Land off Bullen's Green Lane, Colney Heath, St Albans

Transport Assessment Addendum

November 2020

Response to Highway Authority and Parish Council Comments

Figure 3.1: Output area for Colney Heath (Parish)

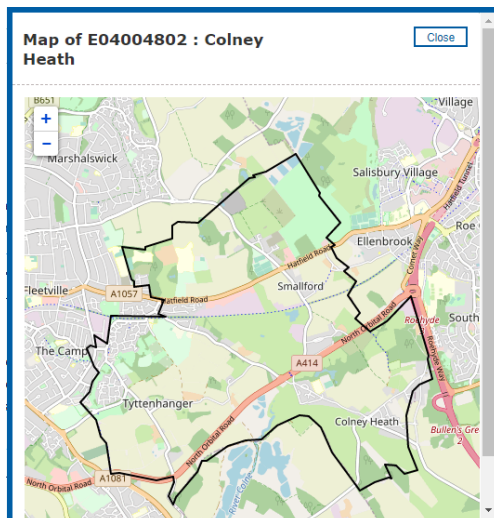
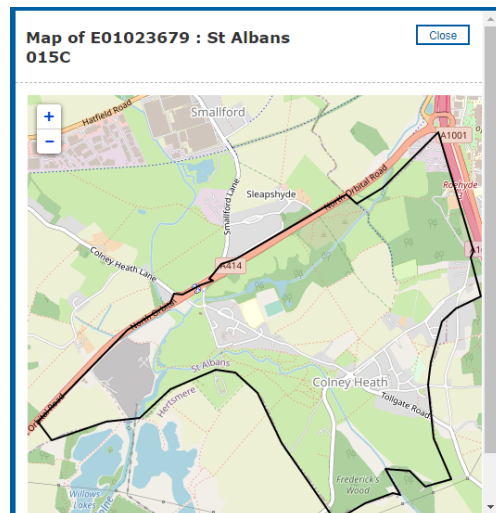
- 3.9 A comment was made in the response of Colney Heath Parish Council in reference to the Census data used to represent the methods of travel to work, and distance travelled to work for the area of Colney Heath in which the site resides. The Parish area of Colney Heath was chosen for both datasets, as shown in Figure 3.1 below; whilst the alternative smaller super output area - lower layer is shown in Figure 3.2. The slightly larger Parish area was used as it allows a good catchment area for workplace destinations and the corresponding datasets for method and distance travelled to work. This influences the catchment area in which workplace destinations are to be determined; which subsequently affects the anticipated trip distribution of the proposed site, and therefore which junctions are expected to experience the greatest impact. It is standard practice to use this dataset for this reason.

- 3.10 As can be appreciated from Figures 3.1 and 3.2 above, the additional area included in the Parish output encompasses primarily rural land, with the small residential areas of Tyttenhanger and Smallford. As previously mentioned, using this area is deemed to benefit the output for workplace destinations, which allows for a more accurate trip generation and junction assessment to be undertaken.
- 3.11 Tables 3.1 and 3.2 below present the 2011 Census data and corresponding percentage for Distance Travelled to Work (QS702EW) and Method of Travel to Work (SQ701EW) for the Parish Output area and St Albans 015C Super Output Area - Lower Layer.

Proposed Footpath Connection Drawing

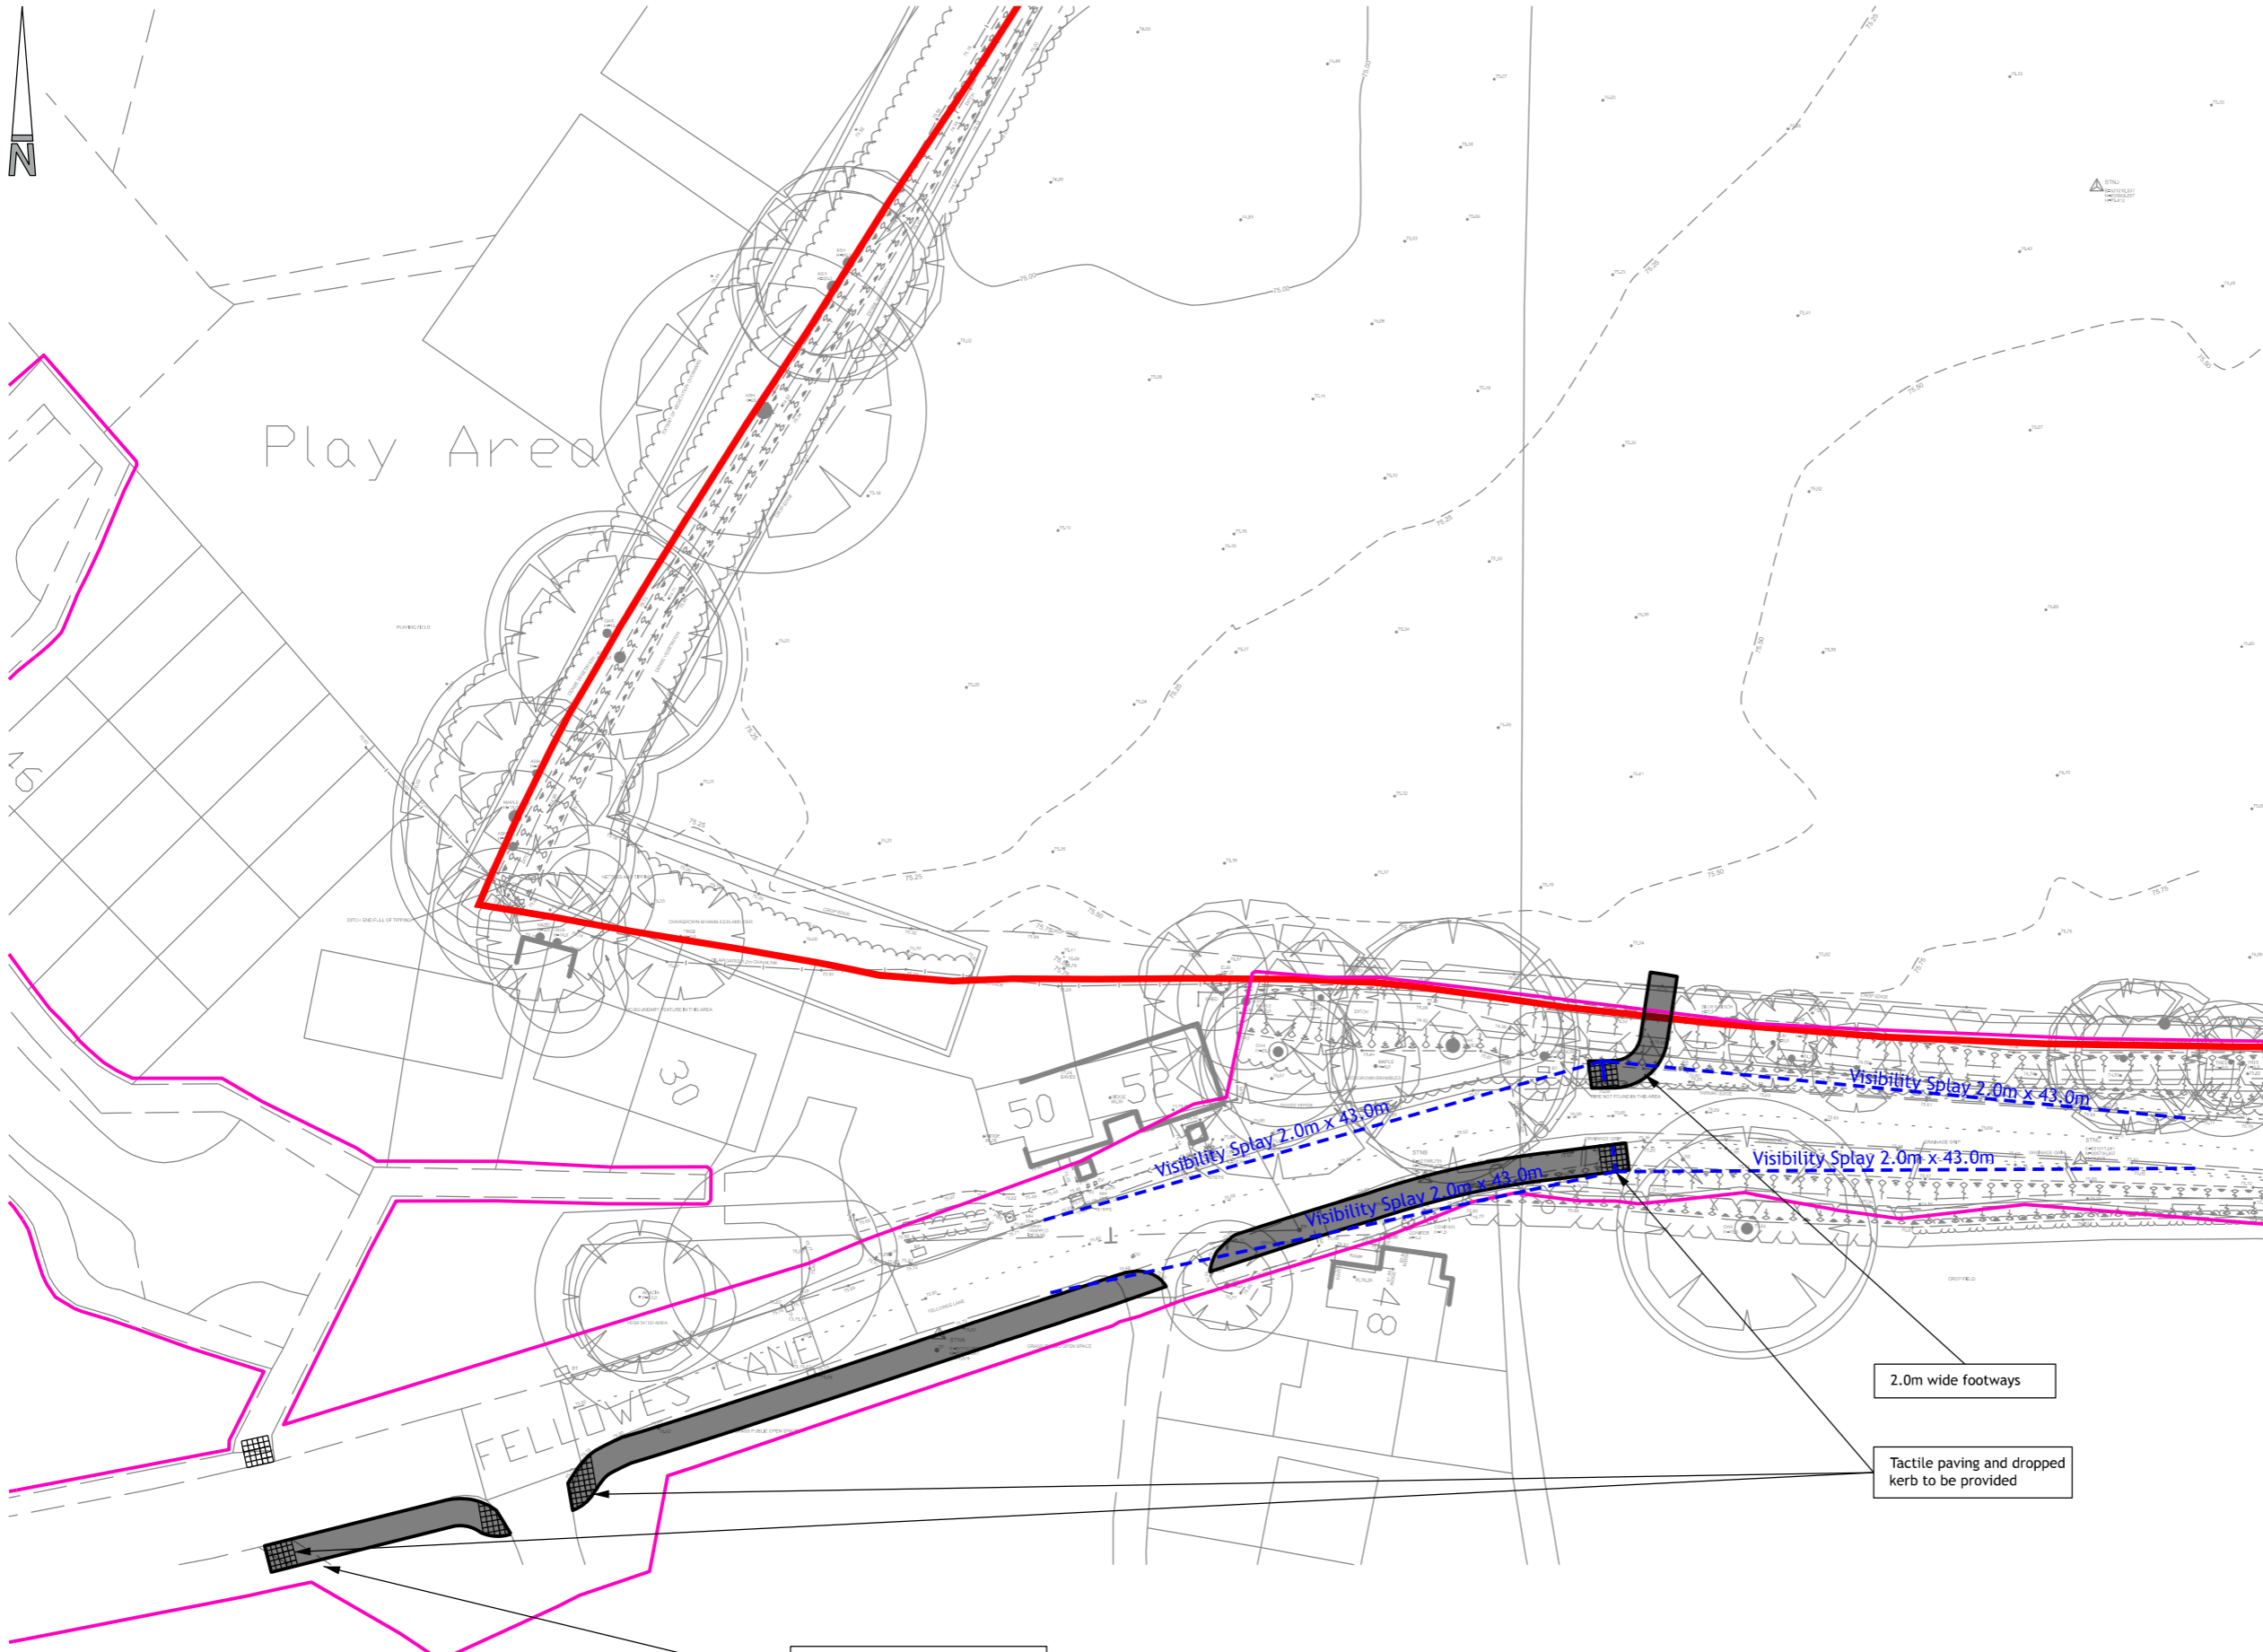
- 3.2 Comments relating to the speed limit along Bullen's Green Lane; specifically in relation to the suitability of a 30mph speed limit roundel in consideration of the fact that dwellings are not directly fronting the carriageway, and therefore drivers may not be aware of the residential nature of the area; are satisfied by virtue of the speed data presented in Section 2 of this Addendum. The data confirmed that average speeds on Bullen's Green Lane are well below the current limit of 60mph, ranging between 28.6mph and 34.2mph.

- 3.5 The Proposed Footpath Connection Drawing (included in **Appendix H**), demonstrates that 2.0m wide footways have been proposed along Fellowes Lane, with a dropped kerb and tactile paving crossing to enable pedestrian movement between the pedestrian infrastructures on either side of the carriageway. This ensures that the development can be safely and conveniently accessed by pedestrians and vulnerable road users. This footpath connection is in place of the route previously proposed through Roestock Park.

- 3.6 A small part of the footpath link will pass close to an existing Oak Tree; the client's arboricultural consultant has advised that this would be acceptable subject to the small area being a no-dig construction. The necessary details will be agreed with the Highway Authority at such time as S278 detailed design drawings are prepared.

Site Access Drawing

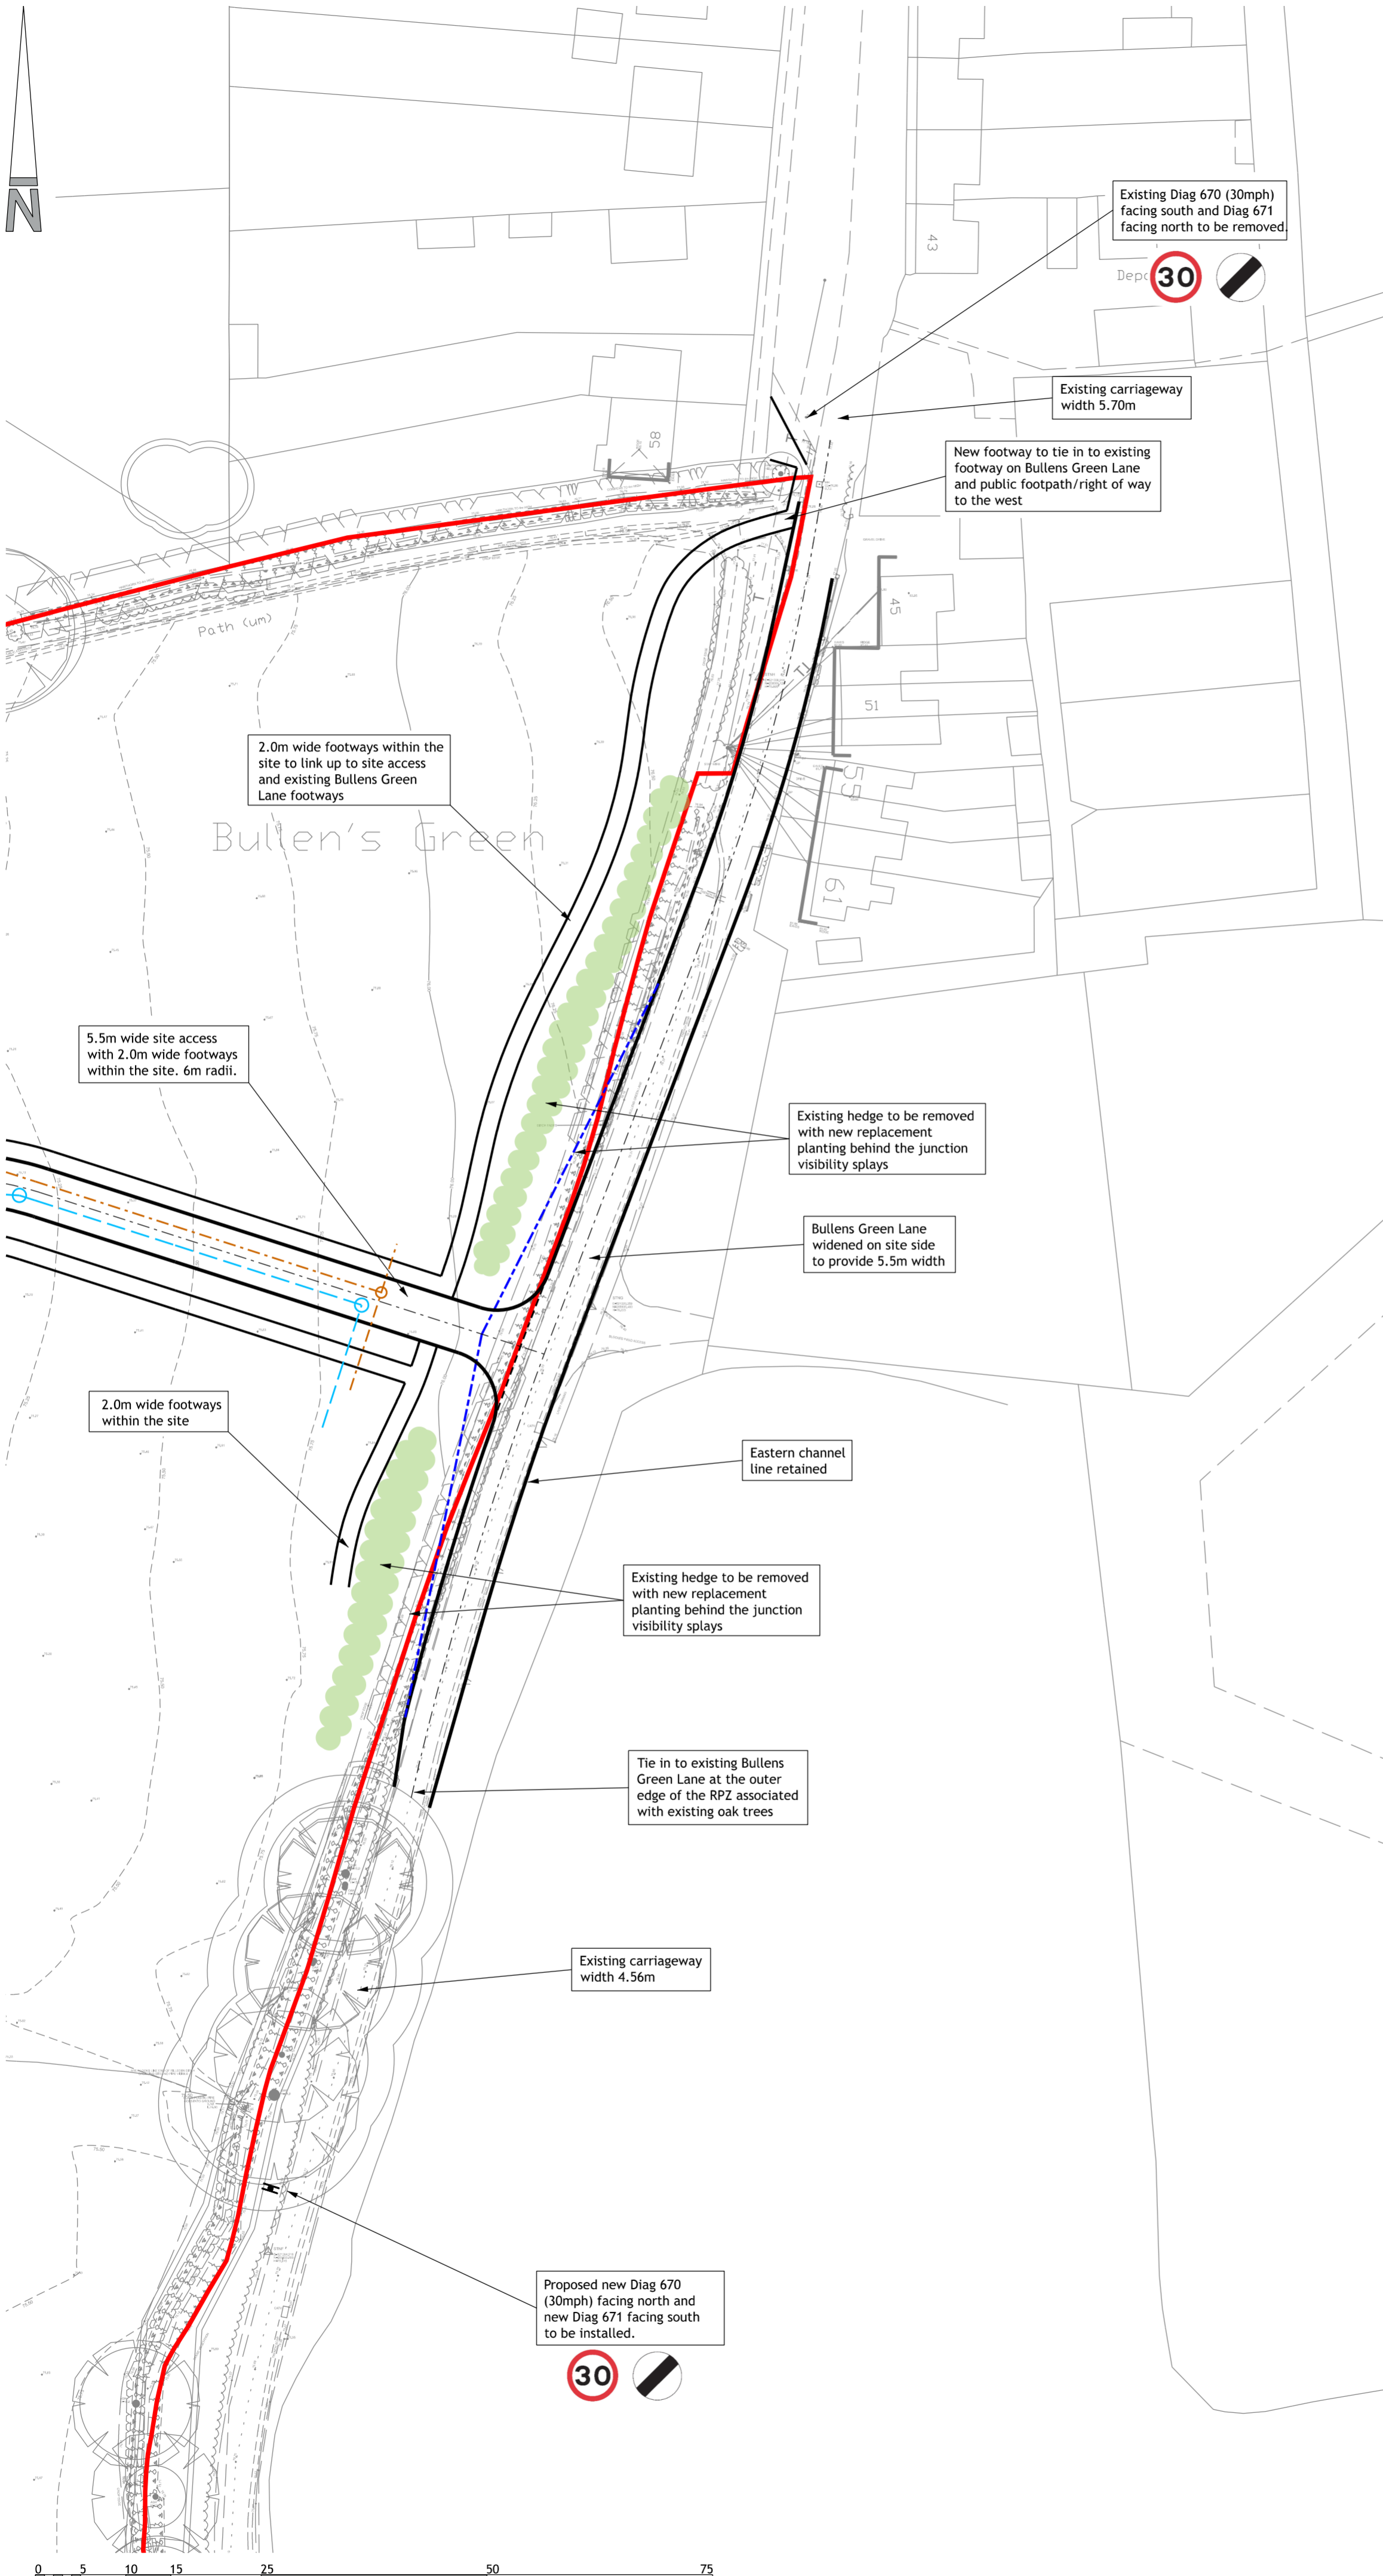
- 3.18 A comment was made with regards to the omission of the fact that 'the farmer has a problem with bringing agricultural vehicles to the site'. This comment was not made within the submitted Transportation document and this is not considered to be a developmental constraint given that the farming vehicles alluded to would not be required to enter a residential development. Furthermore, it has been demonstrated that a refuse vehicle can comfortably enter and exit the site and the proposed access works also include localised widening of Bullen's Green Lane.

- 3.7 The Refuse Tracking Drawing (included in **Appendix I**) demonstrates that the largest refuse vehicle can suitably access the dwellings and bin collection points within the proposed development site. This also addresses the radii of the junction and concludes that it is adequate for the anticipated use of the access.
- 3.8 Bullen’s Green Lane is proposed to be widened to 5.5m along the site frontage. Details of this can be viewed on the Site Access Drawing included in **Appendix J**.
